Docket No. 52-002

Subject: Response to NRC Requests for Additional Information

Reference: Letter, Structural and Geosciences Branch RAIs, T. V. Wambach (NRC)
to E. H. Kennedy (C-E), dated September 26, 1991

RESPONSE TO NRC REQUESTS FOR ADDITIONAL INFORMATION
STRUCTURAL AND GEOSCIENCES BRANCH

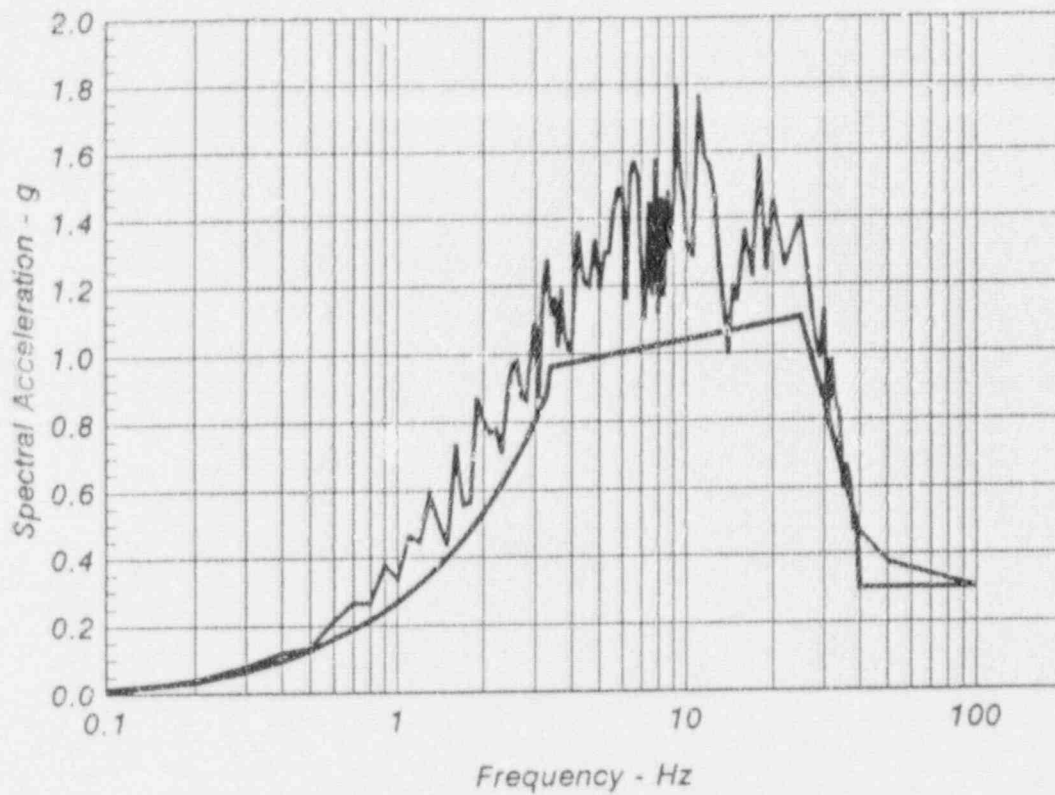
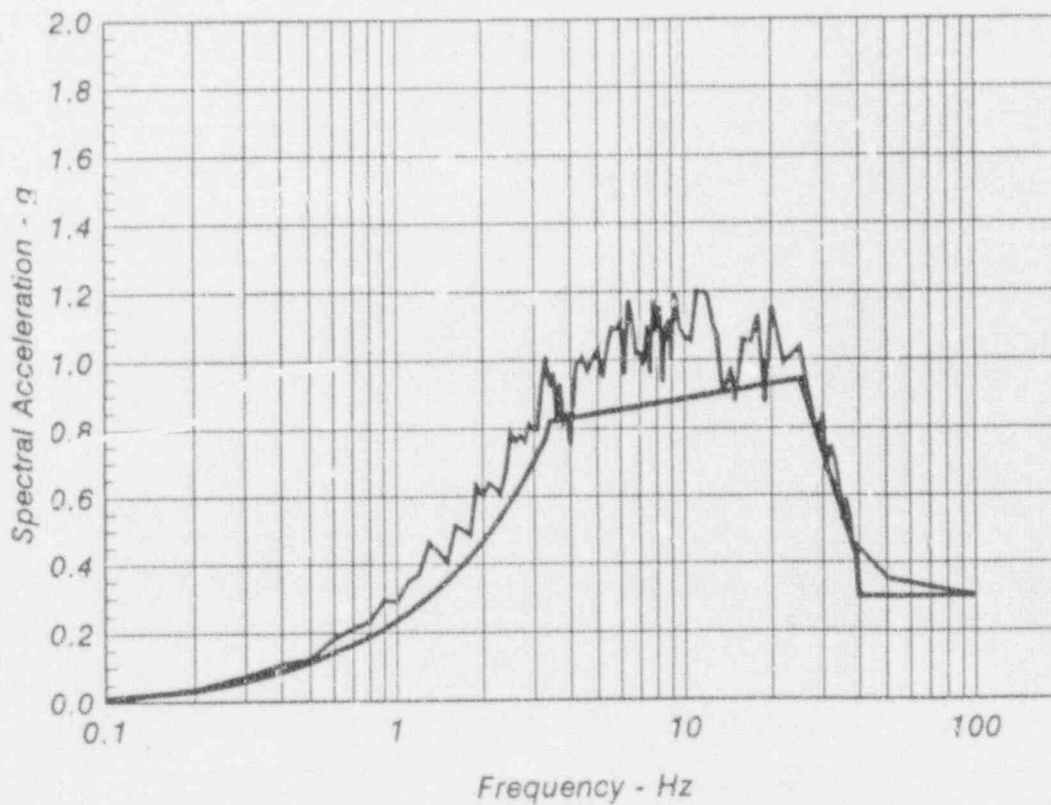
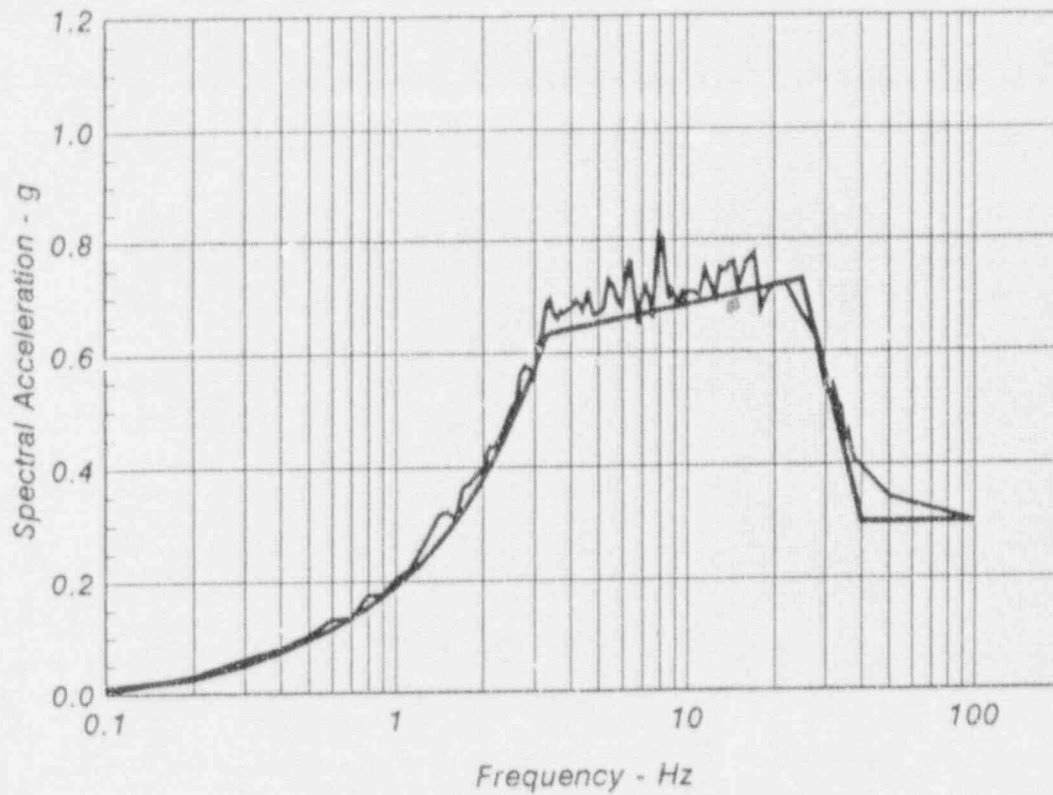
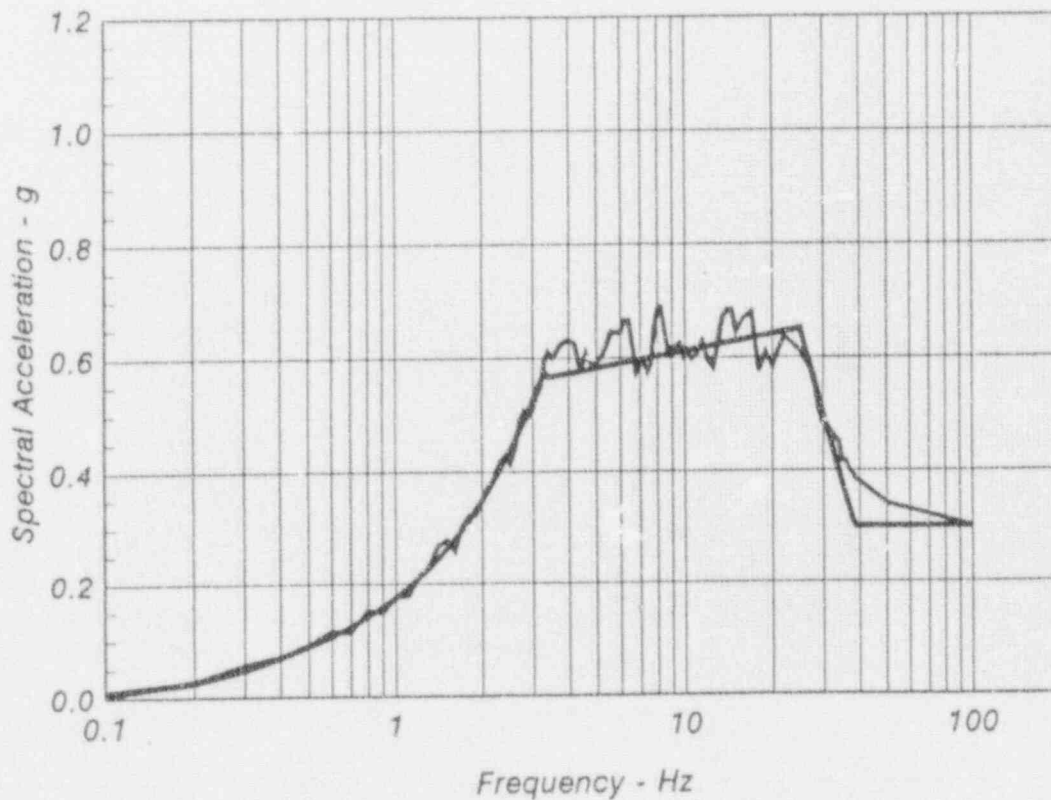
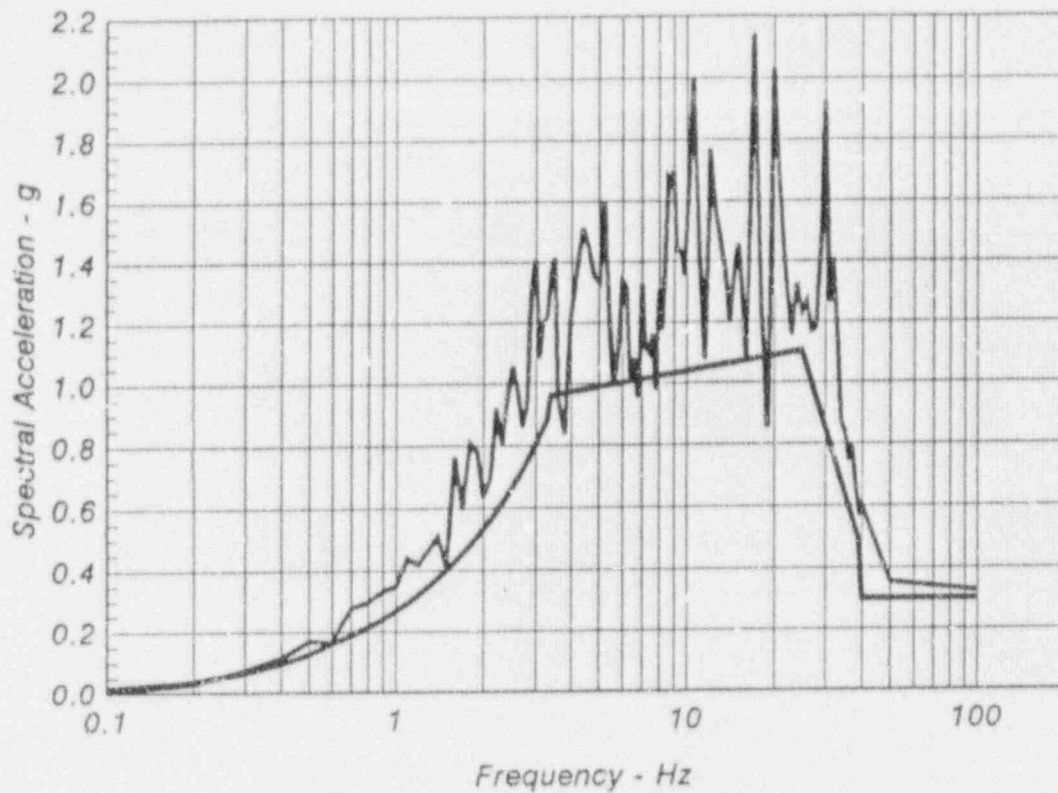
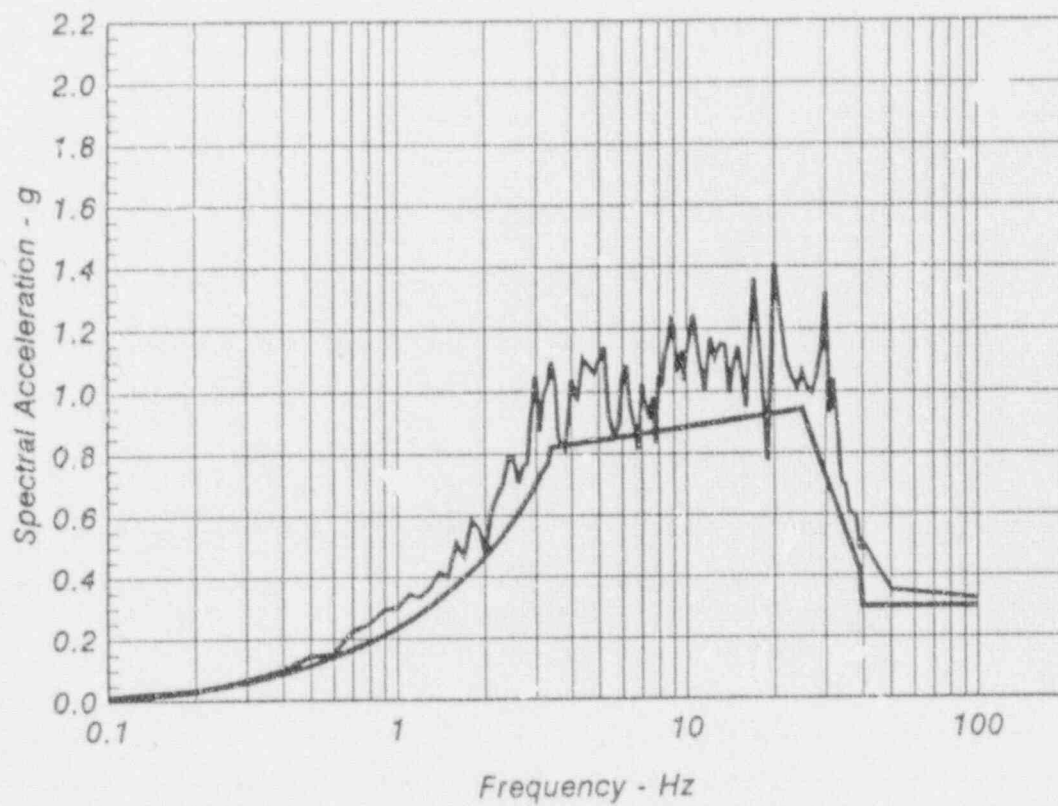
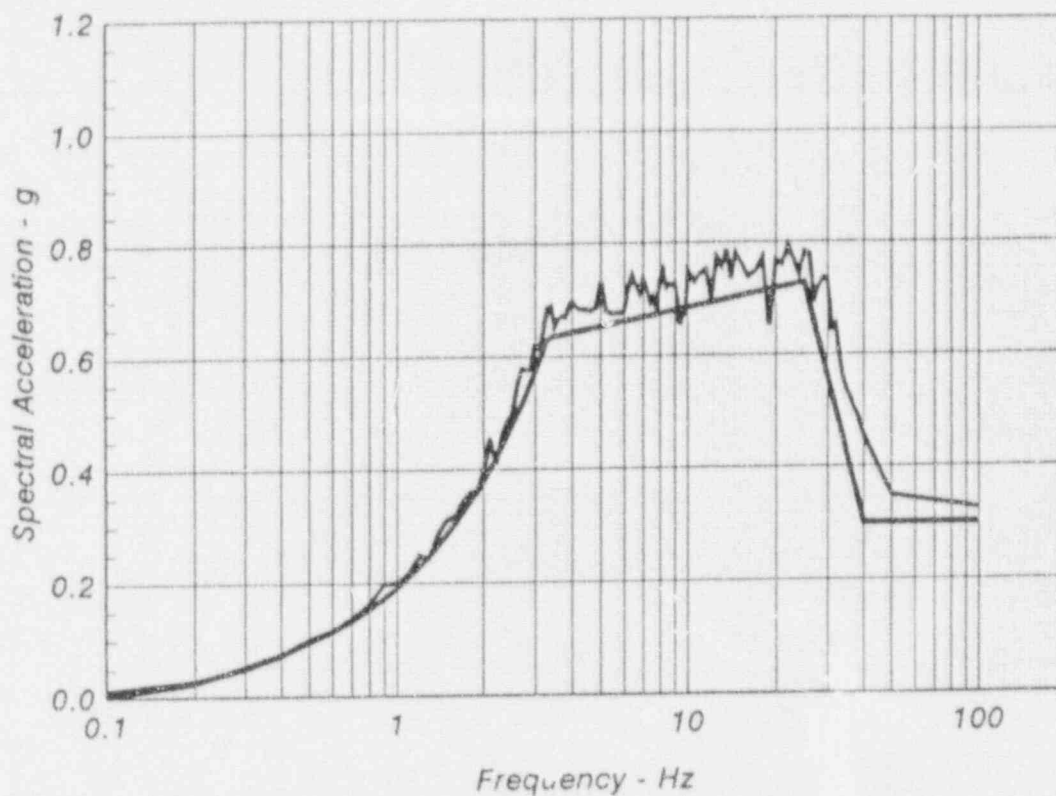
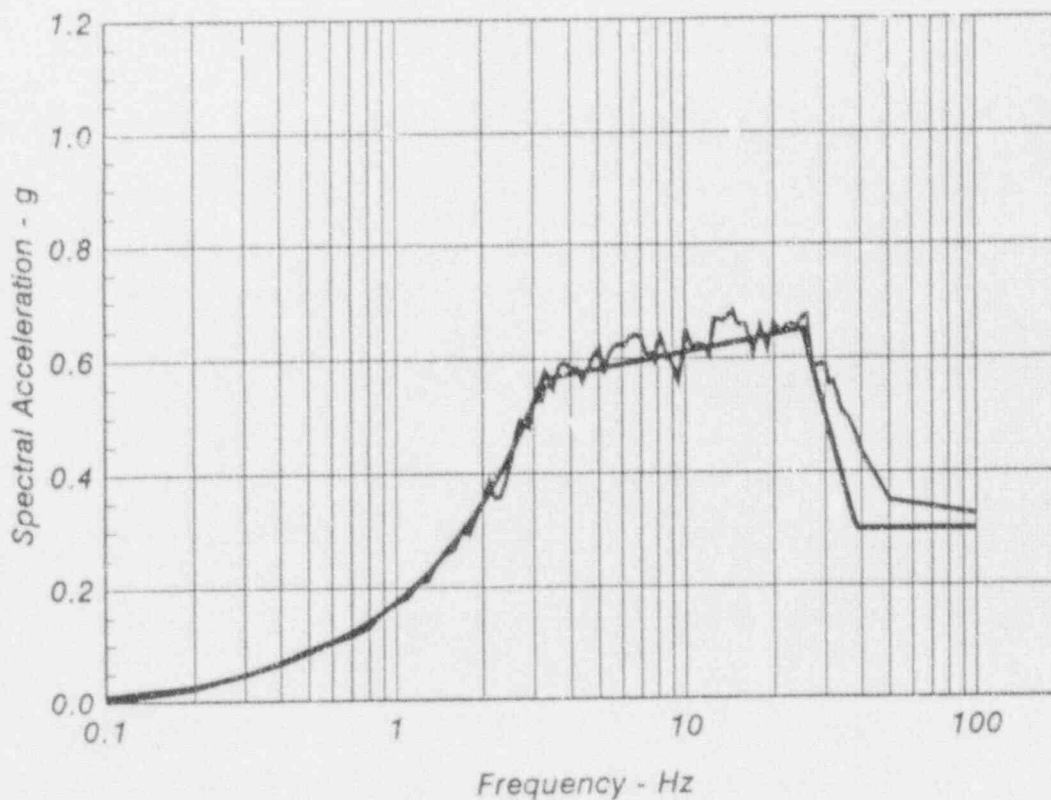
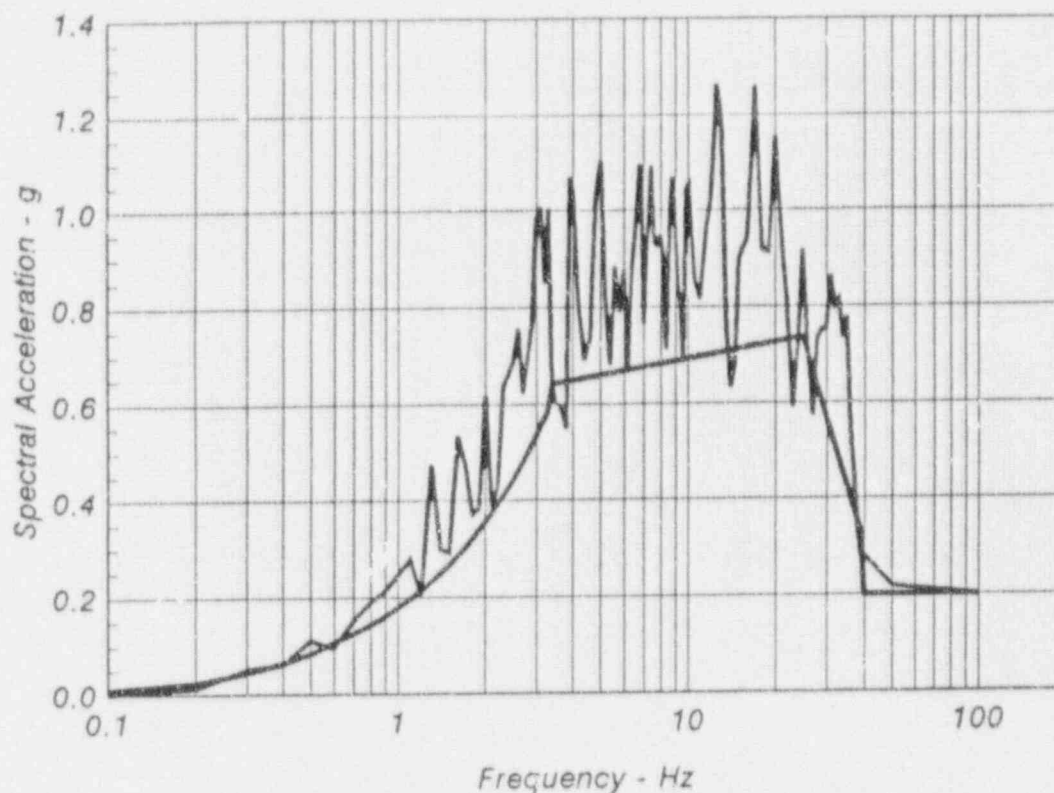
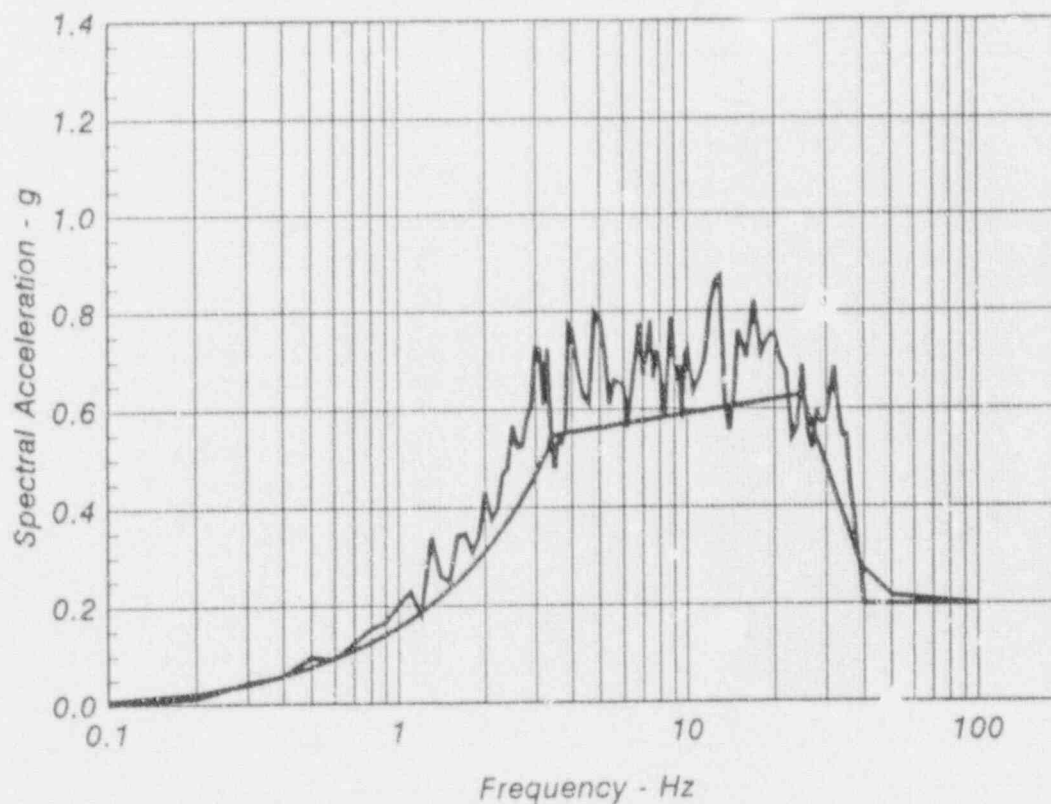
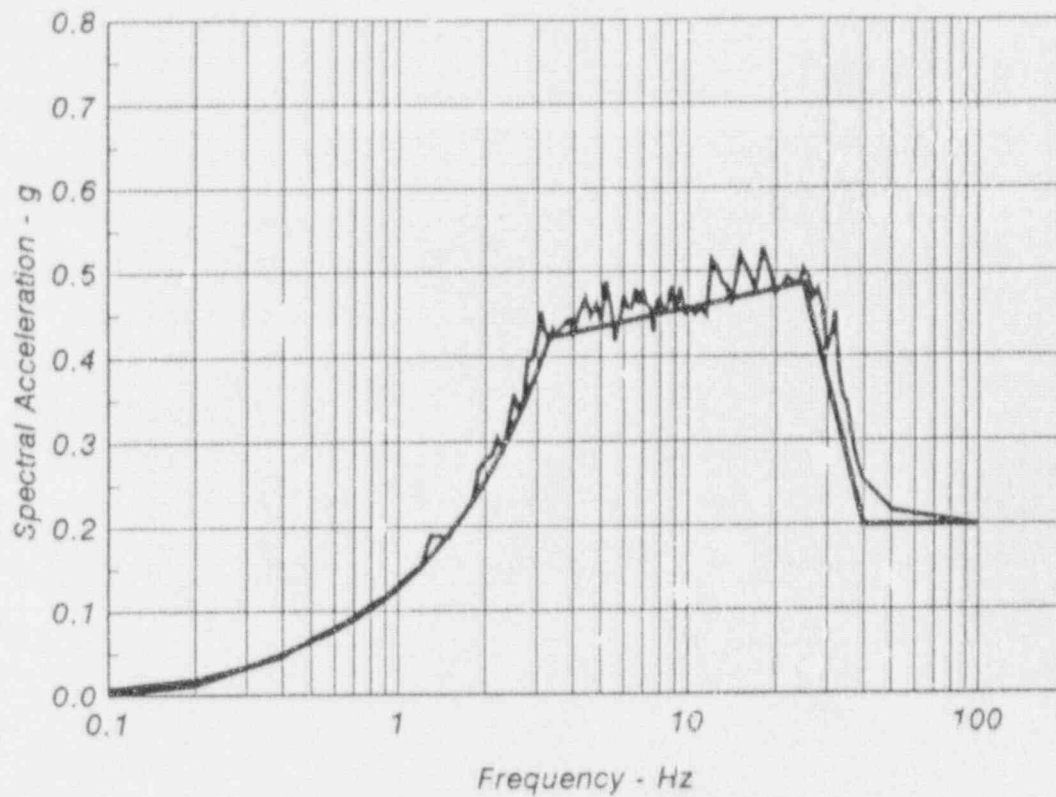
Section 3.7.1.2 - Figures 3.7-25 through 3.7-27 are for damping values of 5 percent. To show the appropriateness of these time histories, provide and discuss similar figures for other damping values that will be used in the design of all Category I structures, systems, and components.

The synthetic time histories H1, H2 and V were generated by obtaining a reasonably conservative envelope to the target smooth spectrum at a spectral damping ratio of 5 percent. The response spectra calculated for these synthetic time histories are presented in CESSAR-DC Figs. 3.7-25 through 3.7-27. The procedure used to obtain the synthetic time histories and the frequencies at which spectral ordinates were calculated are summarized in the response to RAI 220.8.

The spectral ordinates of the target smooth spectrum were estimated for spectral damping ratios other than 5 percent using, as a basis, the spectral amplification factors recommended by Newmark and Hall (1982). The following median and 84th percentile factors were proposed by Newmark and Hall:

The above equations were used as follows: (i) the spectral amplification factor for a given spectral damping ratio was divided by that for $\beta = 5$ percent to obtain an "adjustment factor" for the given spectral damping ratio; and (ii) the adjustment factor was then multiplied by the spectral ordinates of the target smooth spectrum (for $\beta = 5$ percent) to obtain the spectral ordinates of the target smooth spectrum at the desired spectral damping ratio. The adjustment factors were calculated for both the median and the 84th percentile amplification factors; as expected the two sets of adjustment factors were very close (differences were no more than about 6%). For the reasons outlined in response to RAI 230.4, the adjustment factors based on the median amplification factors were used herein to obtain spectral ordinates for the target smooth spectrum at spectral damping ratios of 1, 2 and 7 percent in addition to those that had been developed for 5 percent damping.

Finally, the spectral ordinates for damping ratios of 1, 2, 5 and 7 percent were calculated for the synthetic time histories, H1, H2 and V and these were compared with the target smooth spectrum for the appropriate damping ratio. These comparisons are provided herein in Figs. 1a through 3d.

Figure 1a shows the comparison for H1 at a damping ratio of 1 percent, Fig. 1b is a similar comparison at a damping ratio of 2 percent, Fig. 1c is for a damping ratio of 5 percent and Fig. 1d is for a damping ratio of 7 percent. Corresponding comparisons are presented in Figs. 2a, 2b, 2c and 2d for H2 and in Figs. 3a, 3b, 3c and 3d for the vertical synthetic time history, V.

The results shown in Figs. 1a through 3d indicate: (i) the spectral ordinates of the synthetic time histories provide a reasonably conservative envelope to the target smooth spectrum at damping ratios from 1 to 7 percent for the frequencies of interest; and (ii) the amount of conservatism increases with decreasing damping.
